Special Use Permit (SUP) Application Report

RE: Administrative Approval (COA-137360-2023) for 3820 Hermitage Road– New Garage material specifications

Site Plan
 3820 Hermitage Road - Detached Garage Plans
 Manuchehr and Rebecca A Amirsoleimani
 City of Richmond, VA

Building Permit - Approved Construction Documents
Under general authority of the Building Code, this approved set of construction documents shall be kept on the job site at all times and shall not be altered without approval from the Building Official. This permit does not approve any Electrical, Mechanical or Plumbing work. This approval does not relieve the builder from complying with manufacturer instructions, Virginia Uniform Statewide Building Code and City of Richmond regulations whether noted, implied or omitted. Approved Plans: 20231117_3320 Hermitage Rd. BLDR-126560-2023 12/13/2023 11:20:35 AM

Structure

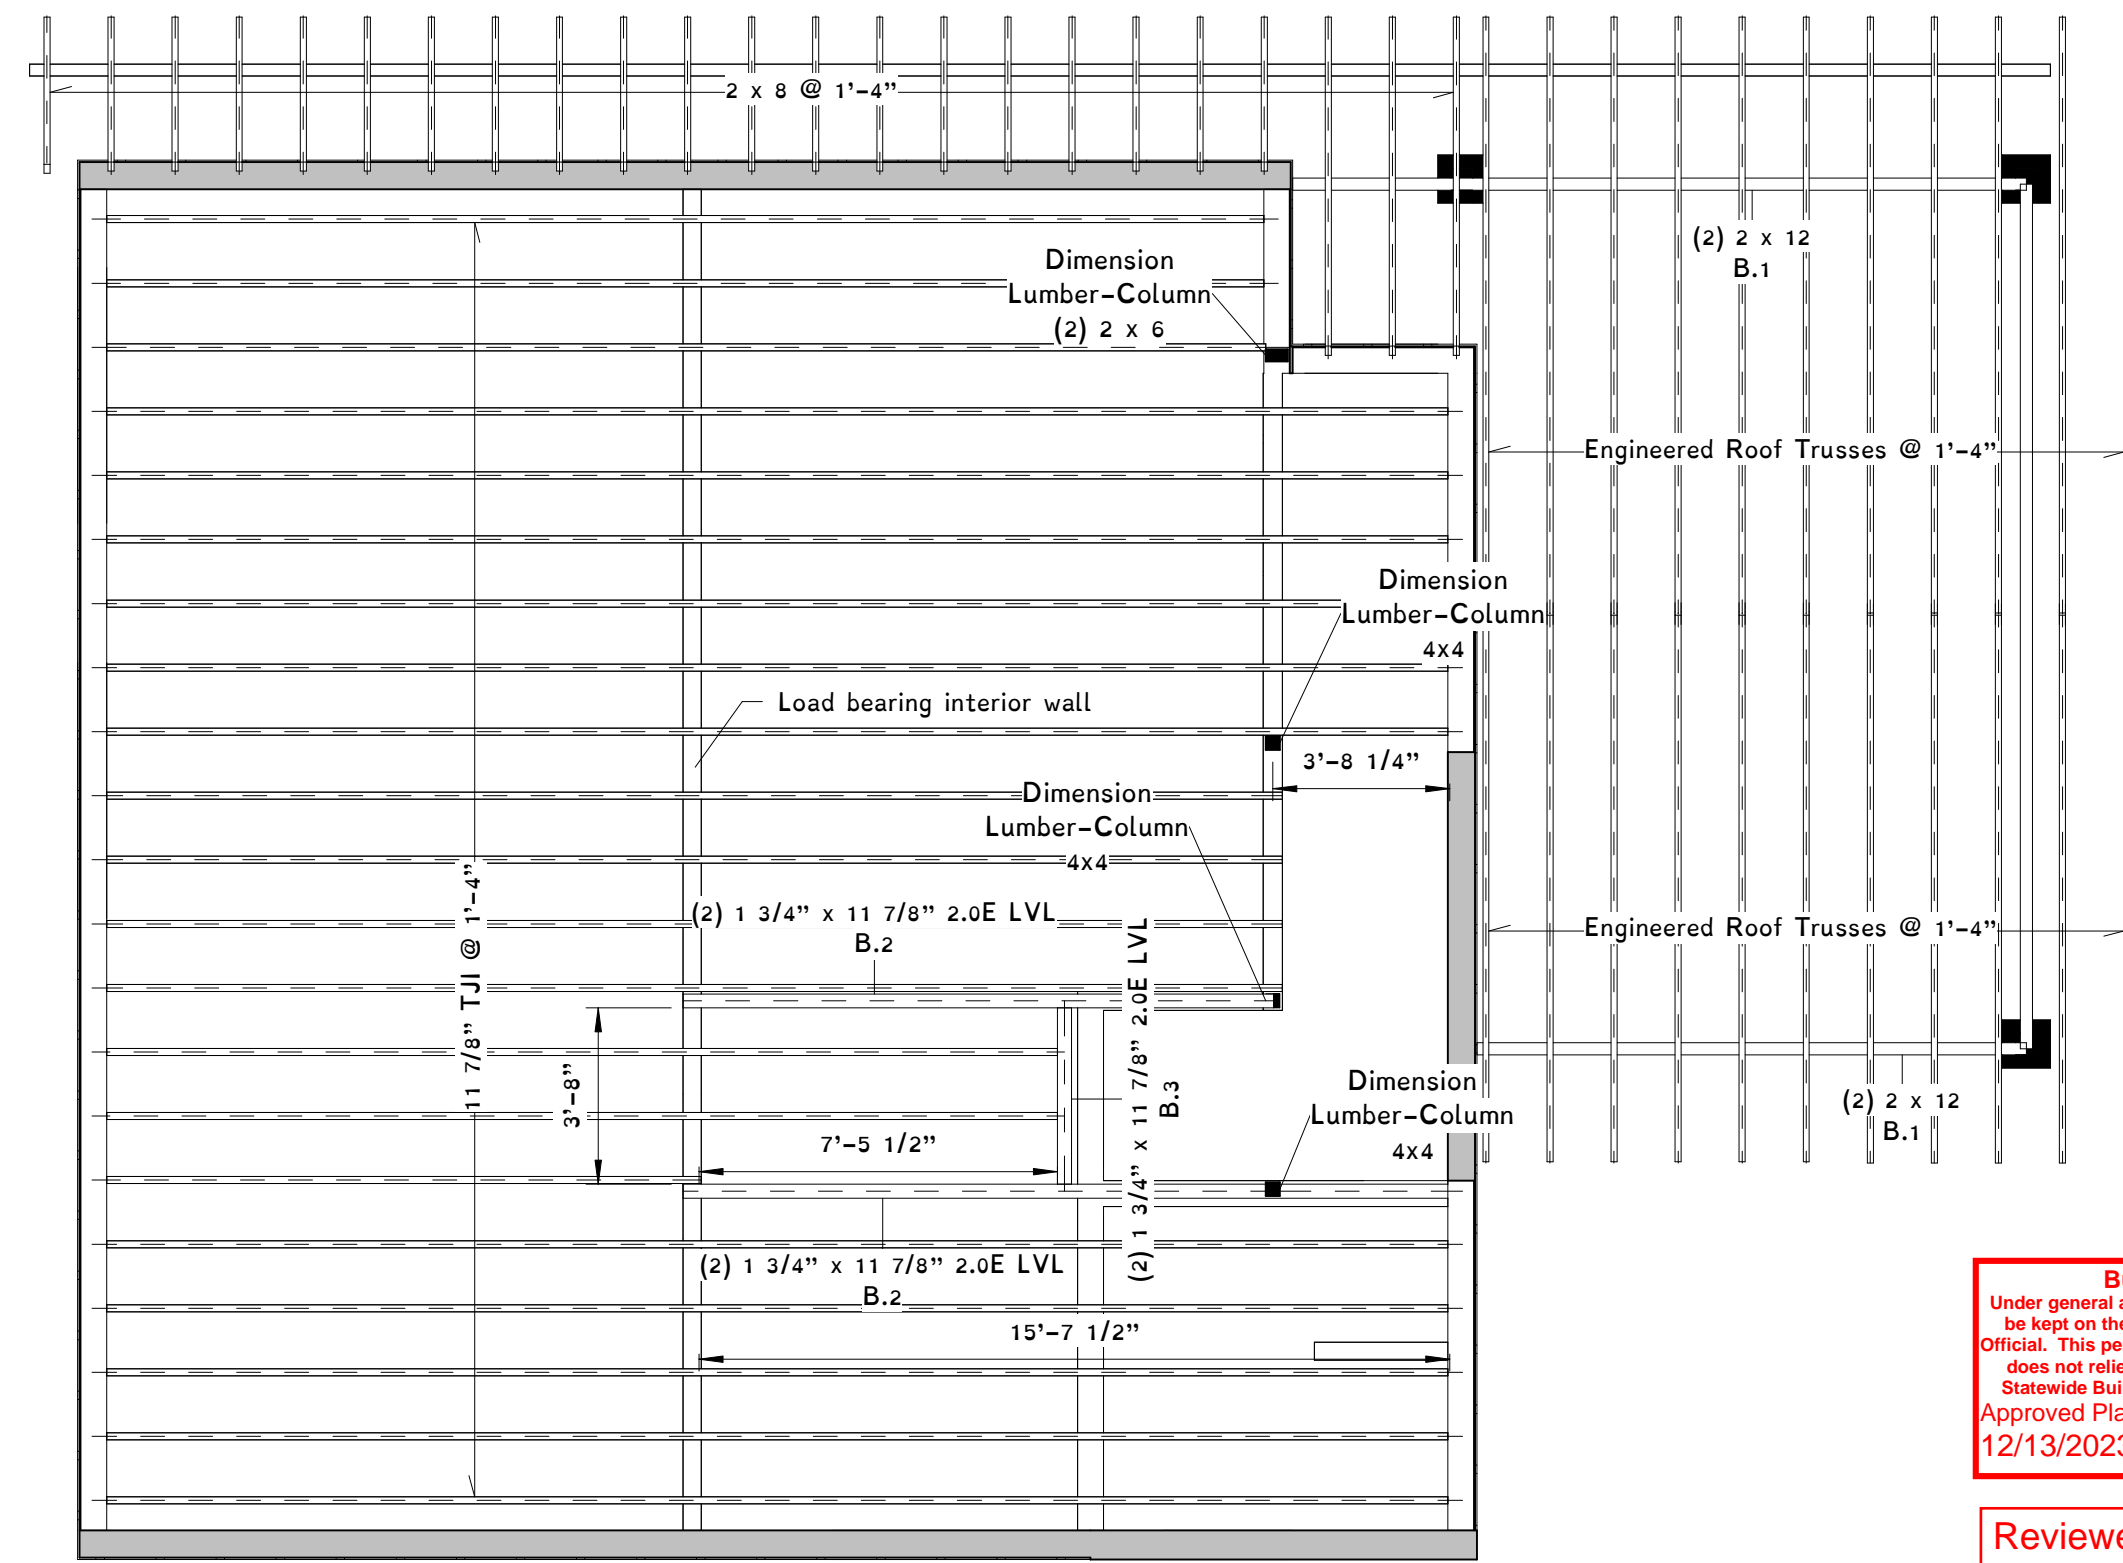
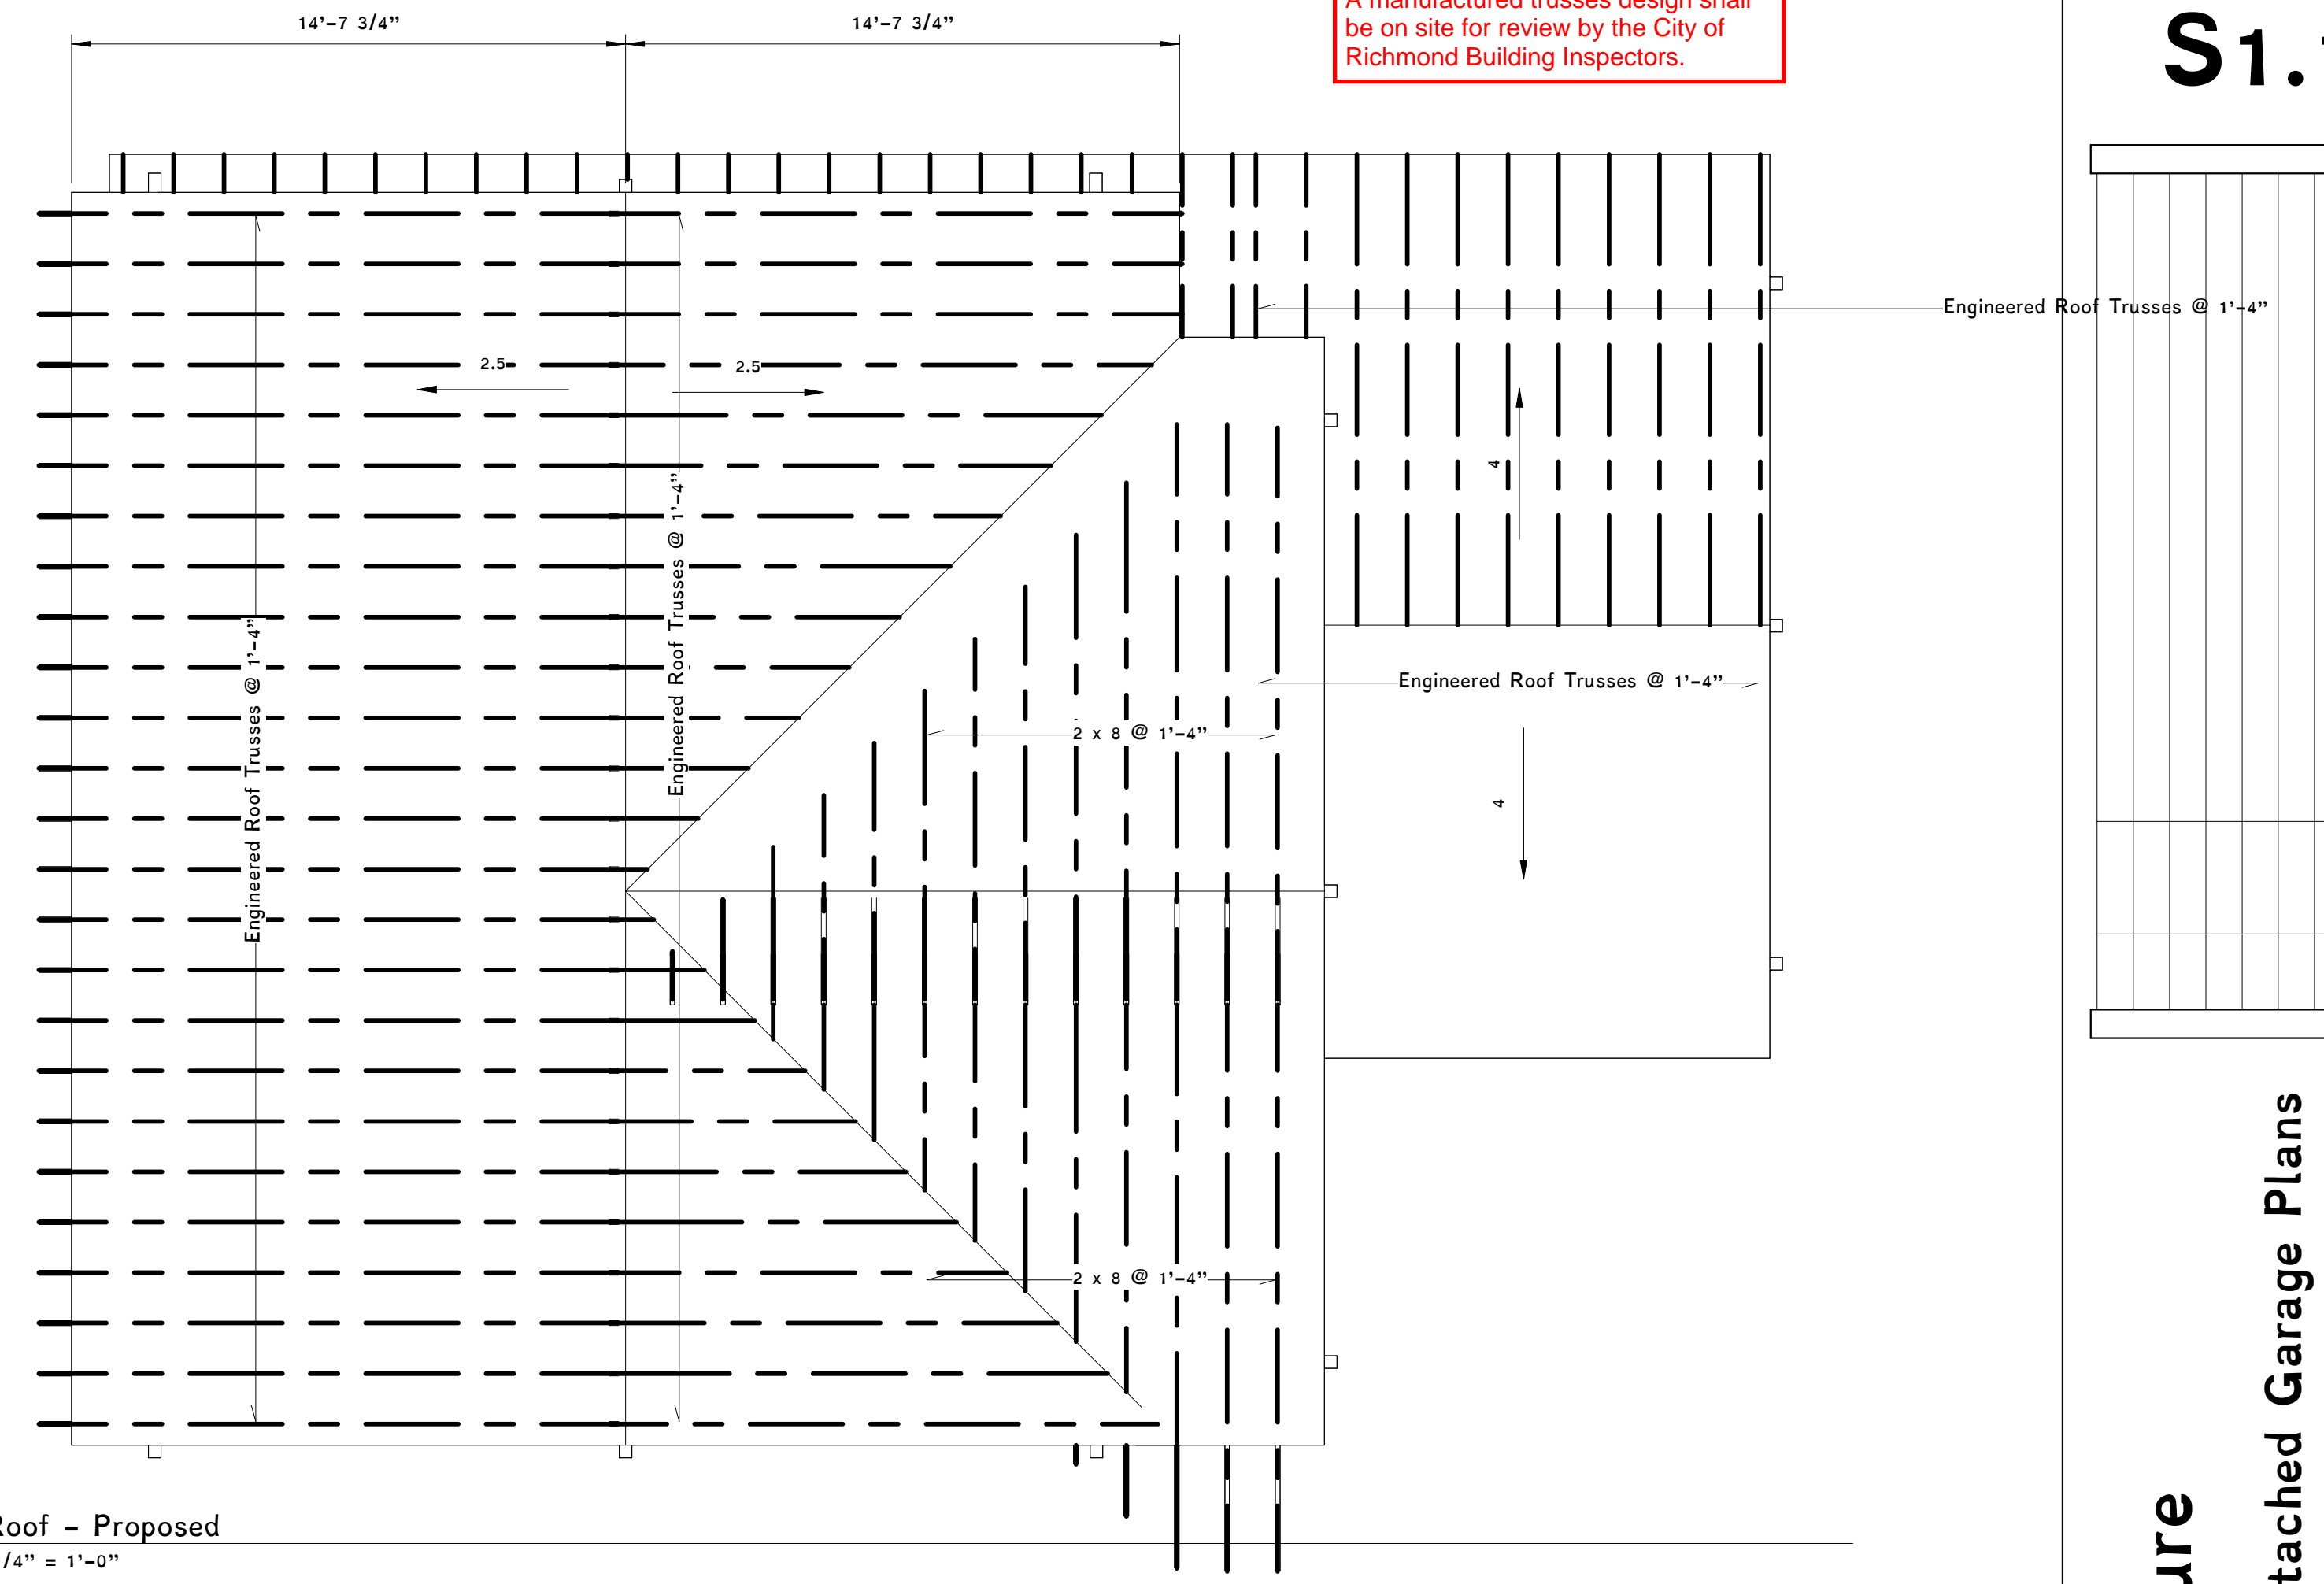
A manufactured trusses design shall be on site for review by the City of Richmond Building Inspectors.
